APPLICATION NO.	FILING DATE	FIRST NAMED INVENTOR	ATTORNEY DOCKET NO.	CONFIRMATION NO.
10/538,008	06/03/2005	Tomoyoshi Yamashita	047991-5019	6861
9629 7590 10/27/2008 MORGAN LEWIS & BOCKIUS LLP 1111 PENNSYLVANIA AVENUE NW WASHINGTON, DC 20004				
EXAMINER				
MAY, ROBERT J				
ART UNIT		PAPER NUMBER		
2885				
MAIL DATE		DELIVERY MODE		
10/27/2008		PAPER

Office Action Summary

DETAILED ACTION

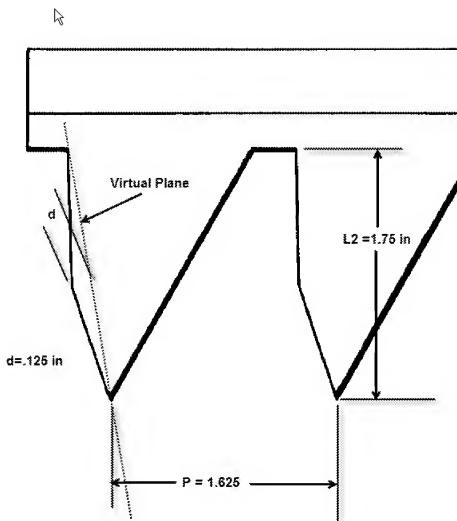
Regarding Claim 12, Miyashita fails to disclose the light deflector as claimed in claim 1, wherein a ratio (d/P) of a maximum distance (d) from the non-single planar surface to a virtual plane connecting a vertex and a bottom of each of the elongated prisms to each other relative to a pitch (P) of the elongated prisms is 0.4 to 5% (instead discloses the $d/P=7.6\%$ see the annotated Figure 16 below)

Regarding Claim 19, Miyashita discloses in Figure 16, the light deflector as claimed in claim I, wherein a pitch P of the elongated prisms and a length L2 of a virtual straight line connecting a vertex and a trough section of each of the elongated prisms to

each other in a cross section thereof as to the second prism face 213a, 213b of each of the elongated prisms shows a relationship of $L2 / P = 1.1$ to 1.7 ($L2 = 1.75$ in and $P = 1.625$, therefore $L2/P$ is approximately equal to 1.1 , see the above annotated Figure 16).
